Subject: Fire Access - 3021 D Street NE

We have a land use project in currently, 24-121106, and we were under the impression from the pre-application conference that fire was not going to have any issues accessing proposed parcel 1 (which has an existing duplex). Planning has indicated since the flag lot access is longer than 150-feet, that we either need to sprinkle the existing structure on parcel 1 or provide a fire turn-around. The access extends past 150-feet to a proposed parking area, but no existing or proposed structures are past 150-feet.

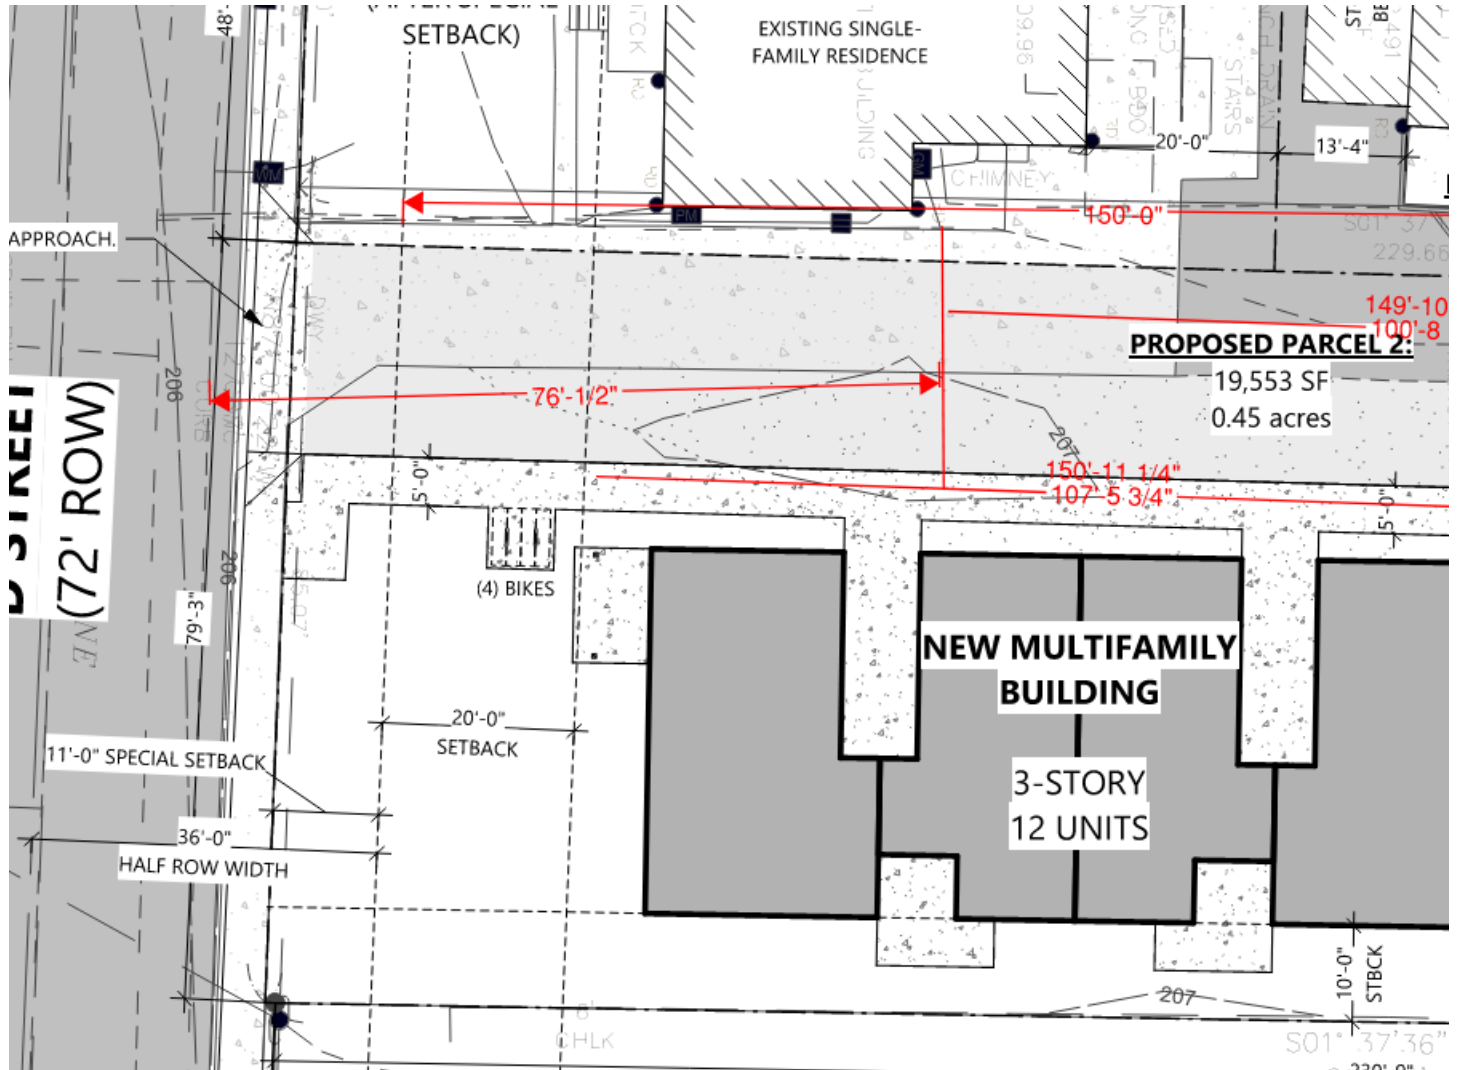
I have attached the submitted site plan, can you please confirm if a fire turn-around or sprinklers in the existing structure on proposed parcel 1 are necessary?

Correct. The first 75' or so of the driveway is fire department access. The next 150' we can reach with our standard hose lay.

It does not appear the fire department access exceeds 150'. FIRE requires an approved fire department turnaround if the fire department access exceeds 150' and the fire code allows some modifications if all structures on that fire department access road have fire sprinklers.
